WOKINGHAM BOROUGH COUNCIL

TREE PRESERVATION ORDER NUMBER: 197/1980

APPLICATION NUMBER: 250378

SITE ADDRESS: 6 SHARPTHORPE CLOSE, EARLEY, WOKINGHAM, BERKS, RG6 4DB

Figure 1

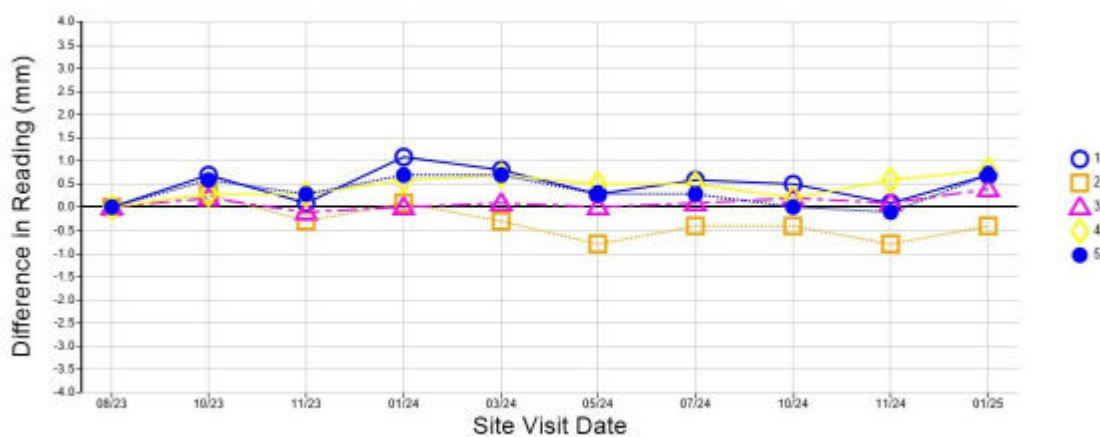
The above statement is only partially correct. The “Level Monitoring Difference Graphs” from the Level Monitoring Report (Figure 1 below) shows that the levels of stations 1 to 5 rose and dropped from 10/23 to 05/24.. This is not a pattern consistent with clay shrinkage subsidence where levels drop in the summer months and recovers in the winter. In addition, the amplitude of movement is so small (about 1mm) and variable that one could argue that there is no observable movement pattern.

In Figures 1 and 2, the level monitoring data is plotted at even intervals on the x-axis, but the sampling dates are not taken at equal intervals, presentation of the data does not accurately represent the trend, making it difficult to interpret the seasonal movement, if any.
